# SUBSURFACE WASTEWATER DISPOSAL SYSTEM APPLICATION

City or Town: **AUGUSTA**

Street or Road: **TOGUS STREAM ROAD**

Subject: Approval, Replacement System Variance Request, Healy property, Togus Stream Road, Augusta

## SUBSURFACE WASTEWATER DISPOSAL PLAN

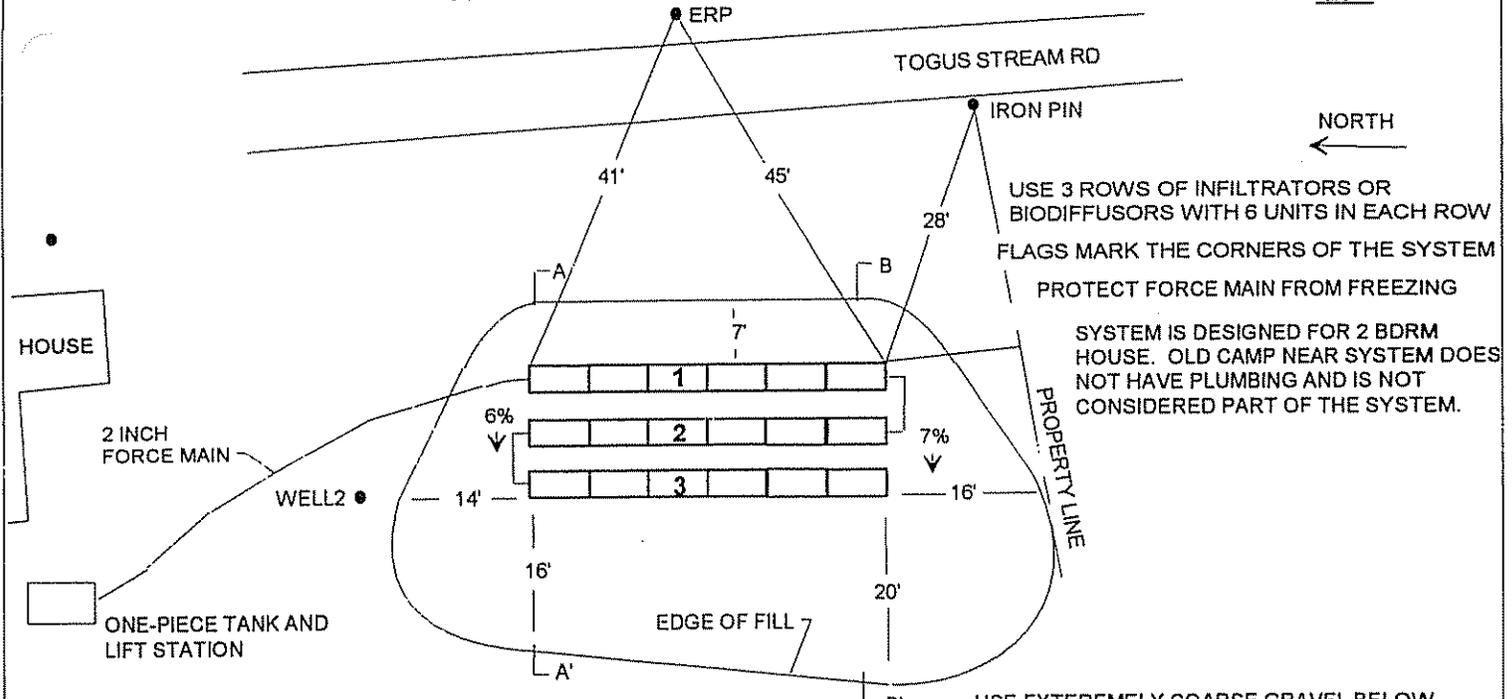
The Division has reviewed a Replacement System Variance Request for the subject property. The variance requested is to allow the installation of an onsite sewage disposal system with a setback distance reduction from the owner's well to the disposal field of 42 feet, septic tank of 25 feet and a major watercourse to the septic tank of 30 feet. Another variance required is a setback distance reduction from a major watercourse to the disposal field of 61 feet. The system design, prepared by William Brown, SE, dated June 4, 2002, is otherwise found to be in compliance with the Maine Subsurface Wastewater Disposal Rules.

We approve the requested variances with the following requirements:

1. A permit for system installation is to be obtained from the Local Plumbing Inspector in advance of the start of system construction.
2. The system is to be installed in accordance with the submitted and approved system design. Should alterations be required at the time of system installation, the system designer must be notified prior to making any changes.

3. The property owner shall complete the enclosed Well Setback Release Form and file it at the County Registry of Deeds, cross-referenced to the subject property's deed. A copy of the filed release, with Registry's stamp, shall be forwarded to this office to complete and validate the variance approval within 90 days of the date of this letter.
